RECEIPT DATE: 7-10-23 **ONSITE SEWAGE DISPOSAL SYSTEM**

APPROVAL DATE: 8/8/2023 **SP PERMIT: CONSTRUCTION**

PROPERTY ADDRESS: 14945 Old Frederick Road

Re: Rizvi Property – Old Frederick Rd.  
OSDS Plan Red line

**LOT 5, RIZVI PROPERTY**  
ON-SITE SEWAGE DISPOSAL SYSTEM DESIGN PLAN  
14945 OLD FREDERICK ROAD  
WOODBINE, MD 21797  
TAX#: 348885, SUB: 1001

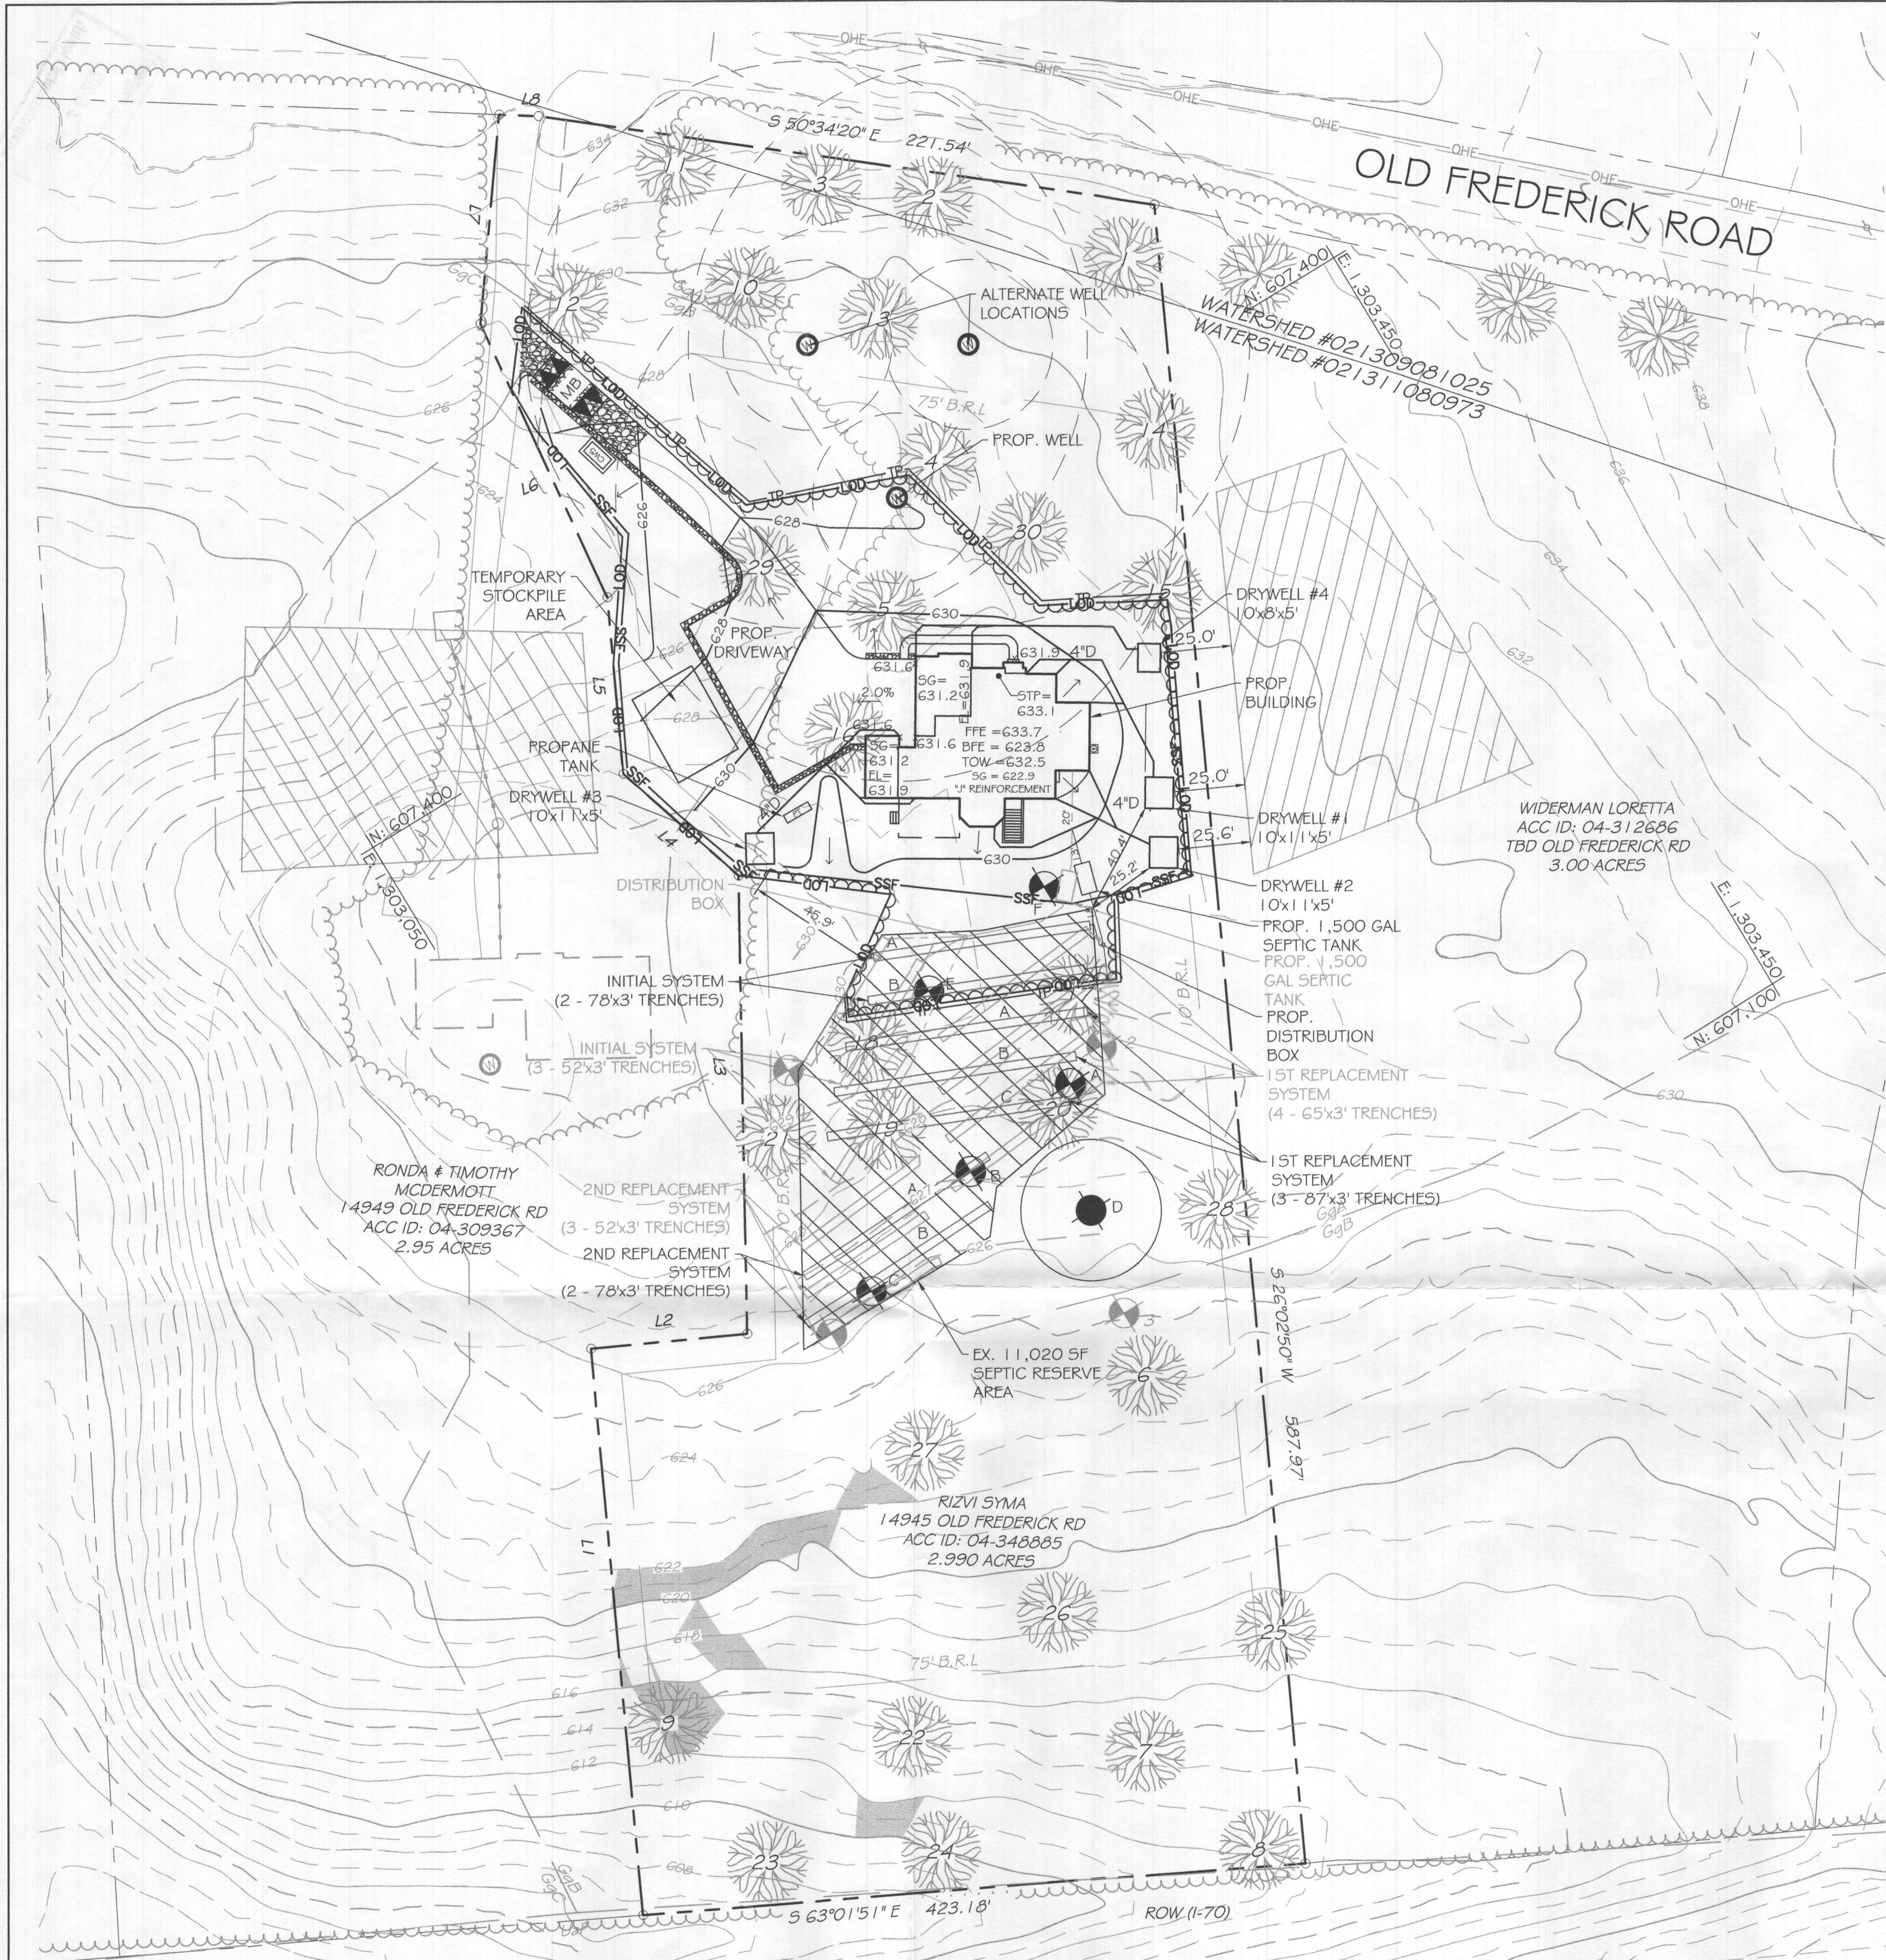
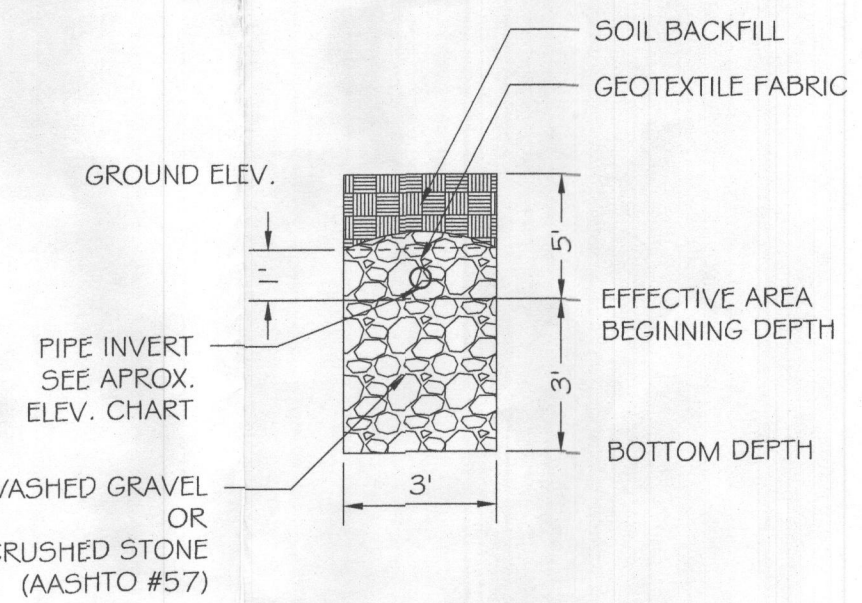
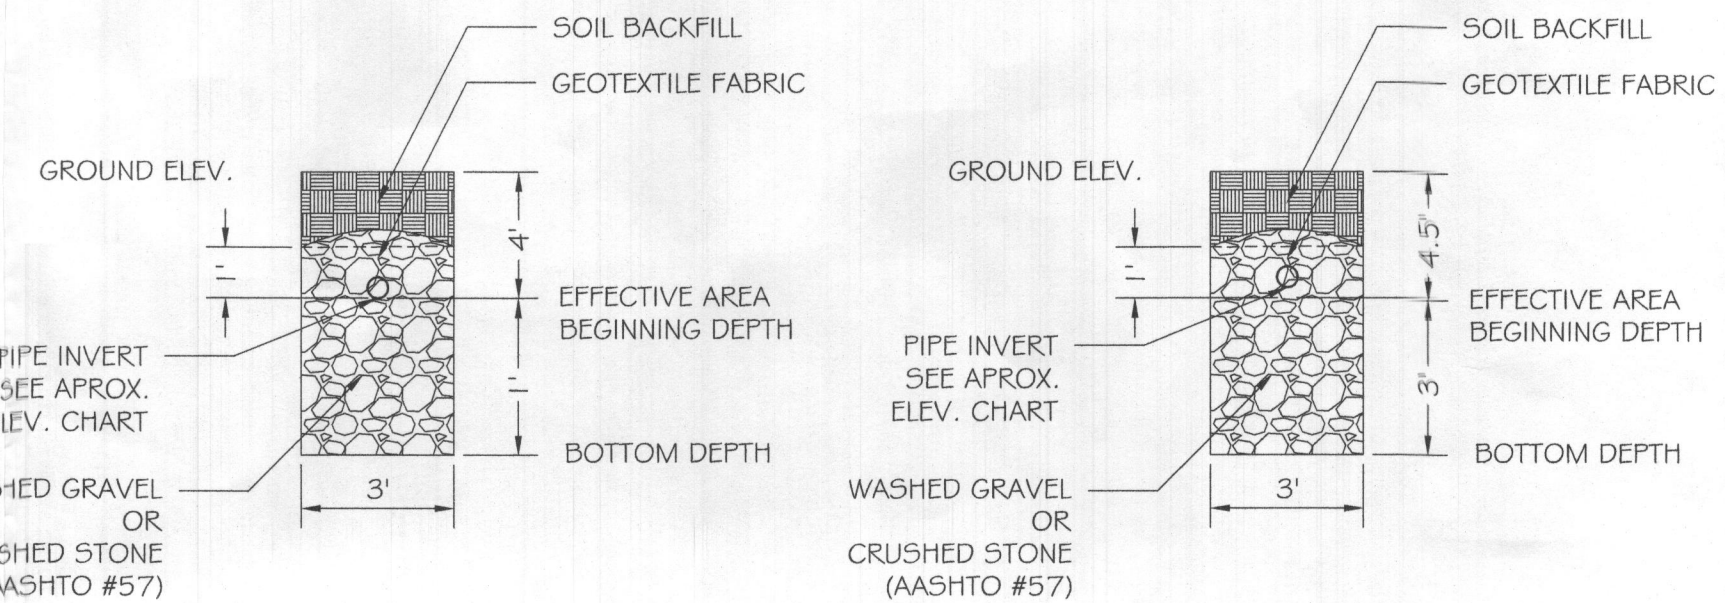
**PRE-CONSTRUCTION:**  
 7/17/2023 - tank staked, SDA staked, trenches staked. upper trench contour off by 5", lower trench contour off by 9". Contour does not match plan, curves towards bottom of site. area redefined plan. contractor not starting any work yet. (S)

8/2/2023 - Met w contractor onsite for layout. 2 upper trenches staked, lower trench not fully staked. told contractor to clear off lot to shoot trench elevations. came back onsite, 1<sup>st</sup> upper trench has less than 2" difference, 2<sup>nd</sup> upper trench less than 1" diff. lowest trench has 2"-9" difference. 15' between upper & middle trench, 18' between middle & lower trench. (S)

My name is Frank White, and I am with KCI Technologies, Inc. we are the engineer on file for Keystone Custom Homes. The septic was installed for a new single-family home located at 14945 Old Frederick Rd, in Howard County, MD. During the installation of the trenches, the pipe was installed at lower elevations than what was approved on the plan. Even thou the elevation of the installed pipe was lower than the approved elevation, the pipe was installed above the designed effective area of the trench. The current location of the installed pipe will not have any affect on the systems function and design. The current installation of the septic trenches meets the intent of the design.

*Read and accepted.*

LOT 5, RIZVI PROPERTY  
ON-SITE SEWAGE DISPOSAL SYSTEM DESIGN PLAN  
14945 OLD FREDERICK ROAD  
WOODBINE, MD 21797  
TAX#: 348885, SUB: 1001

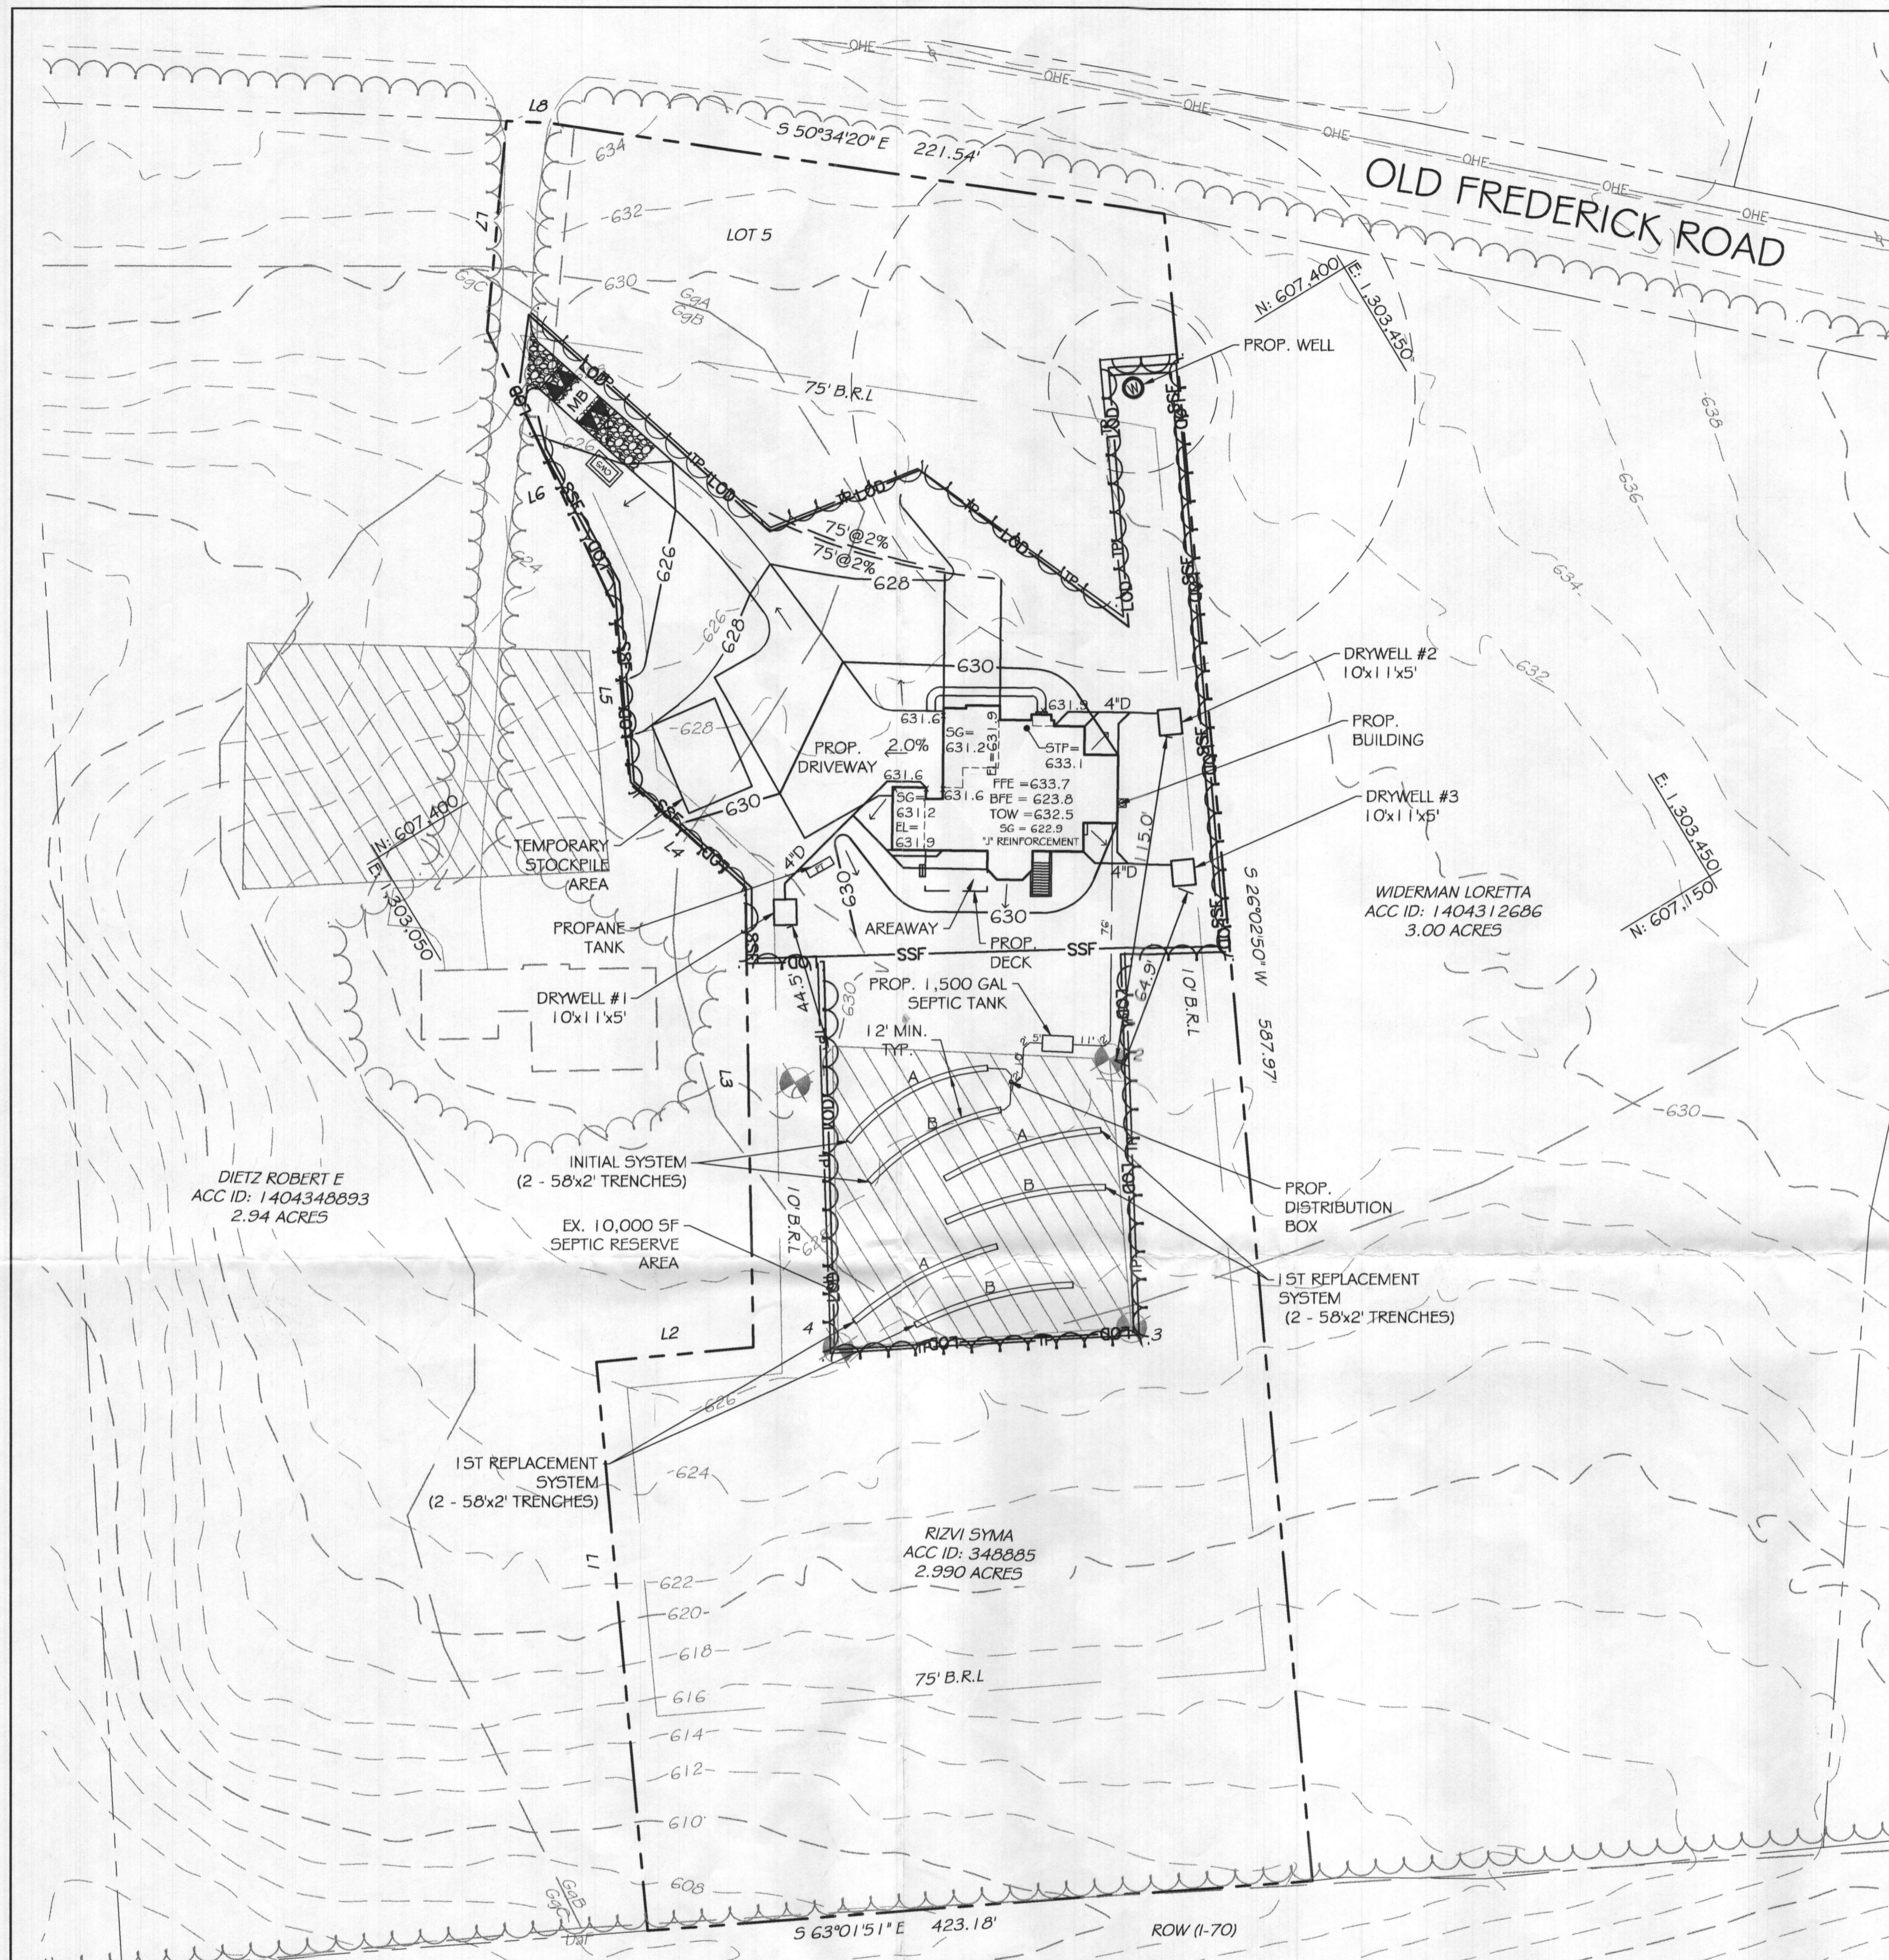
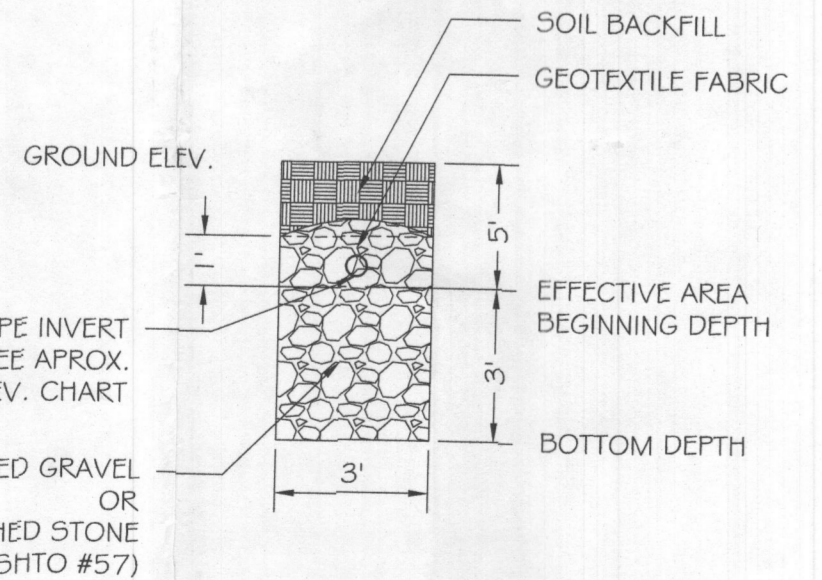
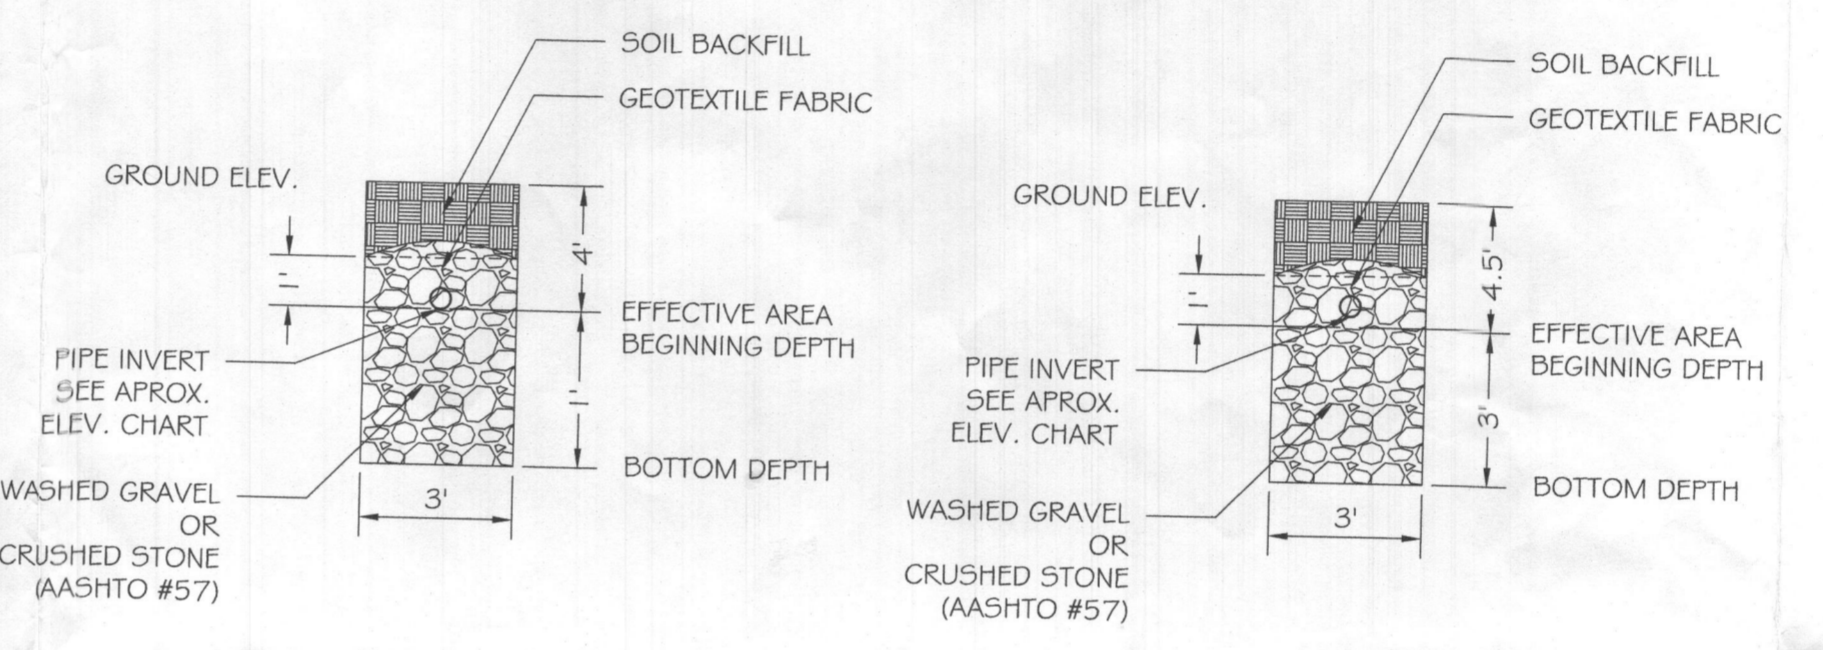
*New Approved*

*OSDS Plan*

*redline. -ZS*
